# SERVICE BULLETIN

ENGINE - MAIN GEARBOX ASSEMBLY - PROVIDE A REWORK FOR THE MAIN OIL SCAVENGE PUMP HOUSING ASSEMBLY TO ELIMINATE AN INTERFERENCE WITH A PUMP PACKING - CATEGORY CODE 8 - MOD.ENG-72-0225

V2500-ENG-72-0225

Oil scavenge pump housing  
Fig.1

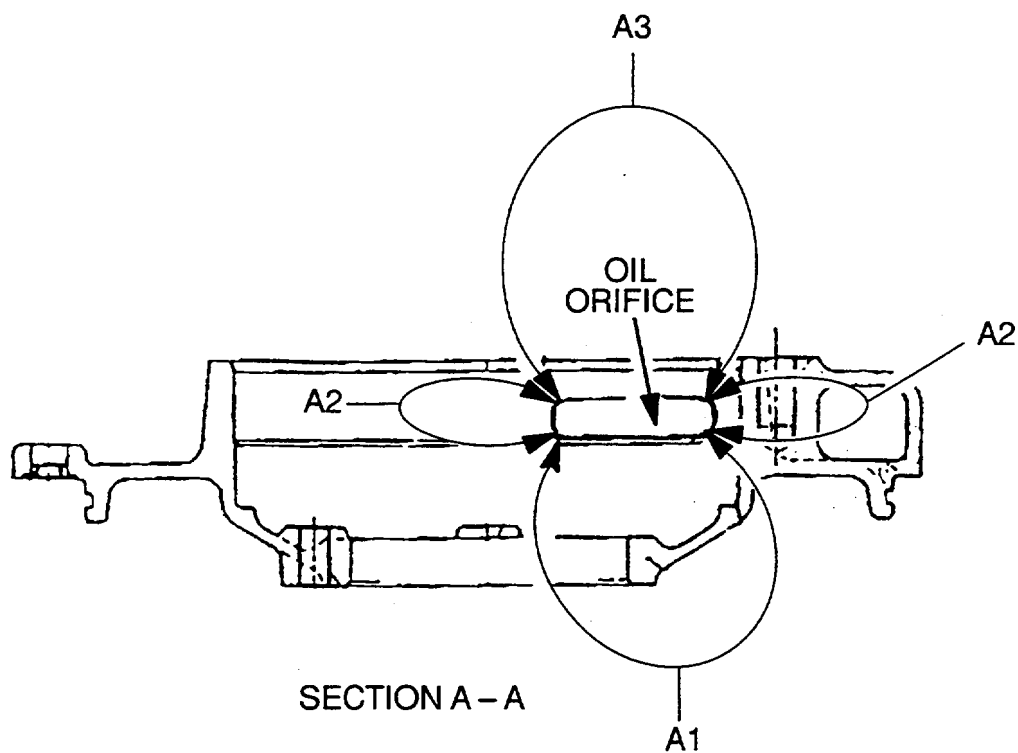
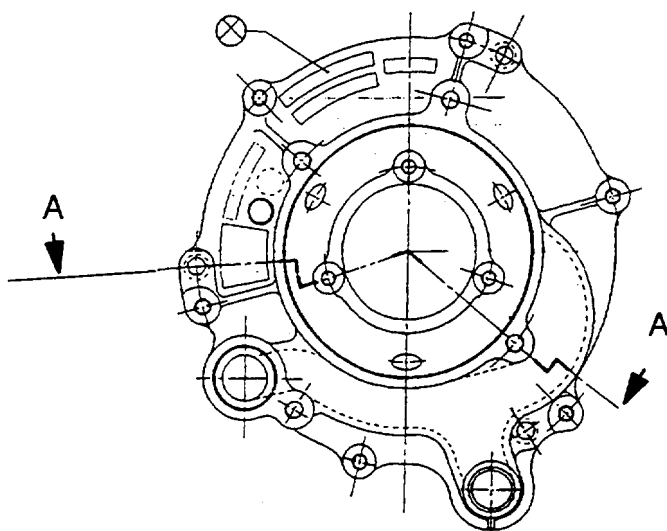
- (a) At the oil scavenge pump installation the front packing fitted on the pump mounting flange could be damaged by interfering with the edges of the oil orifice present in the pump housing.

- (1) Old Part Number 4B2216, Oil scavenge Housin can be reworked to the new configuration (See Figure 1)

- (1) Blend edges in the area A1.  
Radius to be 0.06in. (1,5 mm)  
approximately.  
Blend in area A2 is optional.  
Do not blend in area A3

Refer to Figure 1.  
Refer to 70-35-03-350-501  
Use CoMat 02-140 triangular  
india stone  
Make sure that blended areas  
are smooth and that no burrs are  
left.

- (2) Cancel the old part number.  
and identify the housing with  
the new part number

Old P/N	New P/N
4B2216	4B2289
See TASK 70-09-00-400-501	
Use vibro-engraving equipment
